Development Review Staff Report

Kechter Farm Mixed Use Townhomes

This is a proposed Project Development Plan (PDP), #PDP210006. The plan would develop a group of six buildings with 27 townhomes and one mixed-use commercial office space at the southwest corner of Trilby and Ziegler Roads in south Fort Collins.

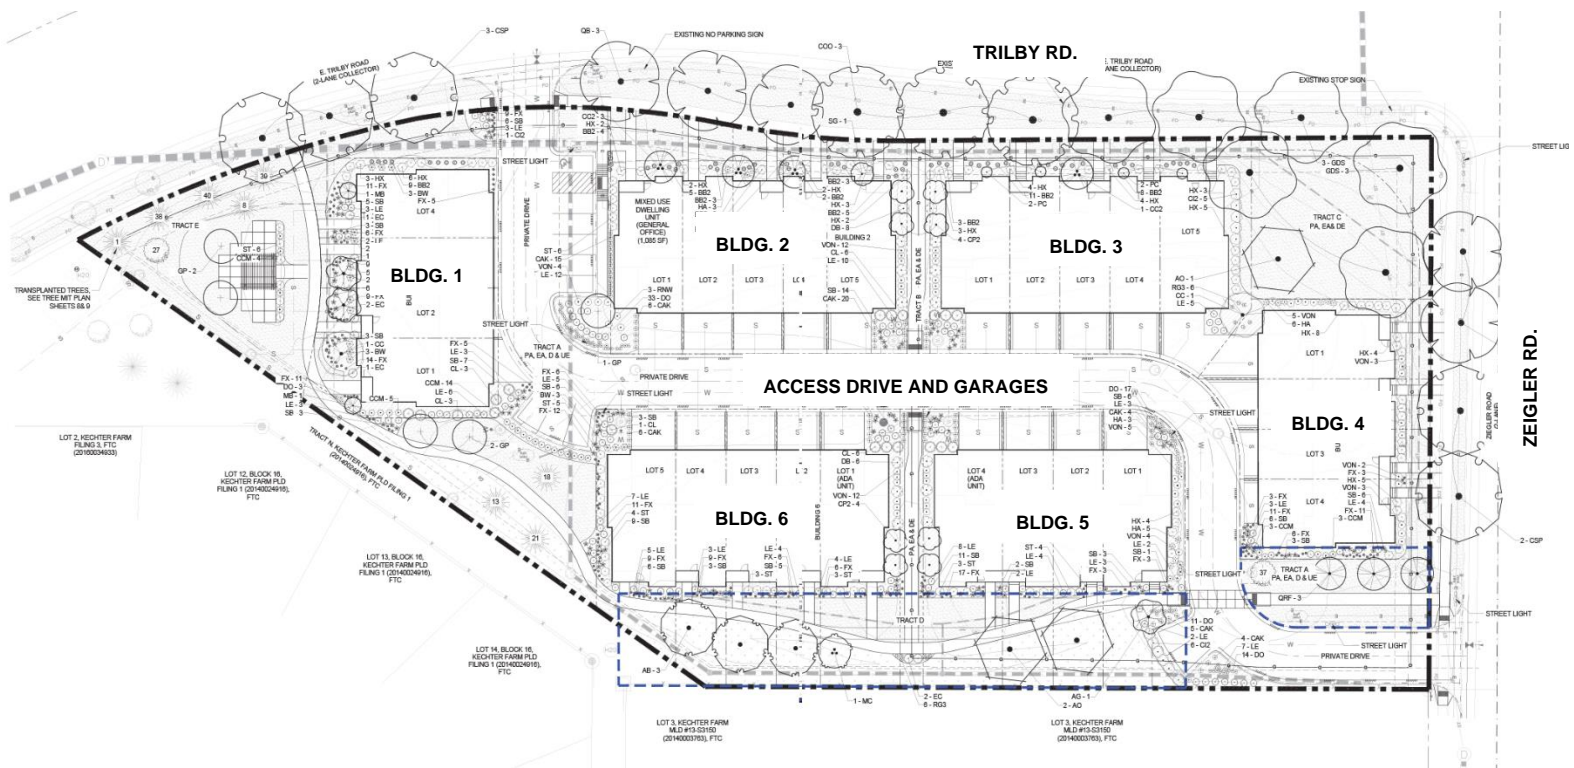
In the proposed plan, buildings 5 and 6 face onto the southern walkway which crosses the entry drive as it leads to the entrances from Ziegler Road, and thus the modification is required.

Detriment to the public good. First and foremost, the plan does place buildings along the street sidewalks (Trilby and Ziegler Roads).

Second, the walkway leads straight across the drive to the front yard area of the buildings, with an enhanced crosswalk at the drive crossing; and the drive is very low-volume and very low-speed, providing private alley-type access to the residents’ garages.

Criterion (1), “equal or better”. To comply with the standard, the plan would have to shift the entry drive northward, which would eliminate a significant portion of building 4, or else push building 4 northward into the open space area which is provided at the corner.

Moving the drive northward closer to the Trilby Road intersection would be contrary to engineering standards for spacing from intersections.

Pushing building 4 northward would detract from the square of open space at the corner which is framed symmetrically by the ends of two abutting buildings to create a clear image and design framework at the highly visible corner focal point.

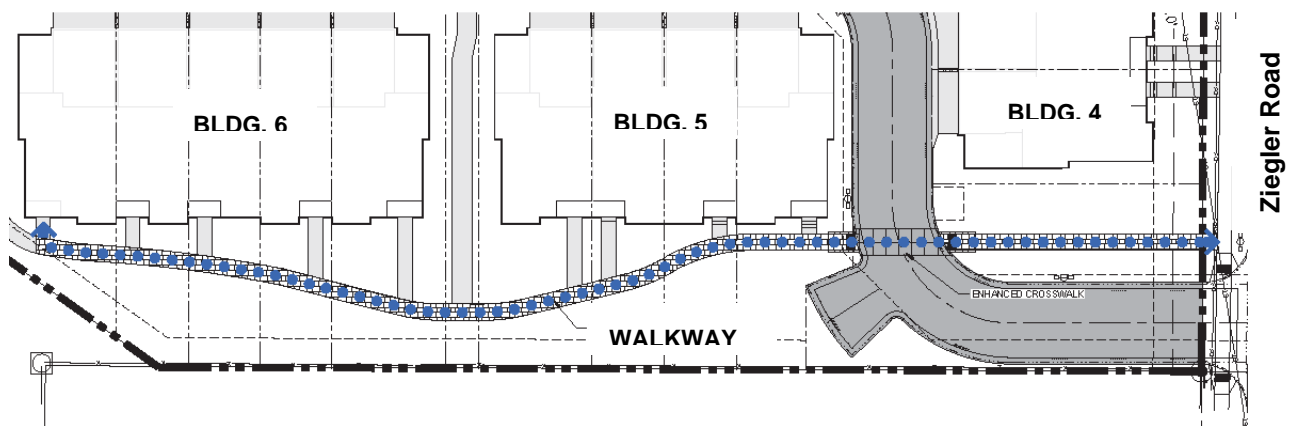
The image below compares the 4-plex (top) and the 5-plex (bottom). One aspect that is not indicated in the image is that the masonry base of the 5-plex has been revised to be stone, and the entry doors will be different in the two building designs.

Staff Findings:

Staff finds that the granting of the modification would not be detrimental to the public good and that the plan satisfies criterion (1), “equal or better” under Section 2.8.2(H) governing modification requests.

Detriment to the public good. The quality of the architecture of this cluster of buildings provides a high degree of visual interest and avoids monotonous repetition. It accomplishes the purpose of the standard with modulated building massing and roof forms within a coordinated and harmonious overall theme, articulated facades with textures in architectural materials, details within the theme, and varied orientation in building placement, such that the six-building group provides positive visual interest to the neighborhood.

Criterion (1), “equal or better”. Staff does not find that changing the design or materials among the buildings would add any visual interest better than the harmonious effect of the six-building group as proposed.

The variation and visual interest in the buildings accomplishes the purposes as well or better than a plan that complies because:

The 4 plex and 5-plex offer a degree of subtle variation in the size and footprint and differences in the masonry, with brick on the 4-plex and stone on the 5-plex.

The differing orientation of building fronts and building ends within the compact cluster also provides variation that mitigates the potential for monotonous repetition, such that only two of the buildings would ever be seen side-by-side, which are the two different buildings, a 4-plex and 5-plex.

The style and architecture of the cluster of townhome buildings adds diversity to Kechter Farm which comprises large tracts of single family dwellings. The design and white color provide a degree of homage to the Kechter farm with a design that reflects ‘modern farmhouse’ style.

Incidentally, staff does not agree with the idea in the request that additional building models would be incompatible with the adjacent single family neighborhood and only create unnecessary visual clutter, because variation in building models is required throughout the neighborhood, with no two of the same model located next to each other. Nevertheless, staff finds that the architecture exemplifies the reason why the Land Use Code allows the “equal or better” provision for modifications of standards as written.
